## ZONING COMMITTEE STAFF REPORT

1. **APPLICANT:** LeCesse Development Corporation **FILE #** 17-016-413
  2. **TYPE OF APPLICATION:** Site Plan Review **HEARING DATE:** 4/13/2017
  3. **LOCATION:** 246 – 286 Snelling Ave S, between St. Clair and Stanford Avenues
  4. **PIN & LEGAL DESCRIPTION:** 102823220164; 102823220165; 102823220166;  
102823220167; 102823220168; 102823220169 (Sylvan Park Addition to the City of Saint Paul,  
All of Lots 1-10 Block 4)
  5. **PLANNING DISTRICT:** 14 **PRESENT ZONING:** B2
  6. **ZONING CODE REFERENCE:** §61.402(c)
  7. **STAFF REPORT DATE:** 4/6/2017 **BY:** Tia Anderson
  8. **DATE RECEIVED:** 3/3/2017 **DEADLINE FOR ACTION:** 5/2/2017
- 
-

**City of Saint Paul – Department of Safety and Inspections**  
**Site Plan Review Report**  
**Date of Report:** April 5, 2017  
**SPR File #** 17-016413  
**Address Location:** 246 – 286 Snelling Ave S  
**Project:** LeCesse Development Multi-Use Development

**DETAILS C8-1**

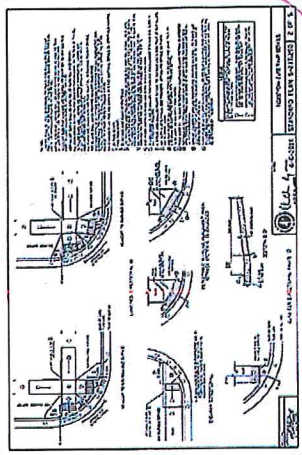
*Handwritten note:* Use updated curbs  
 Standard plans
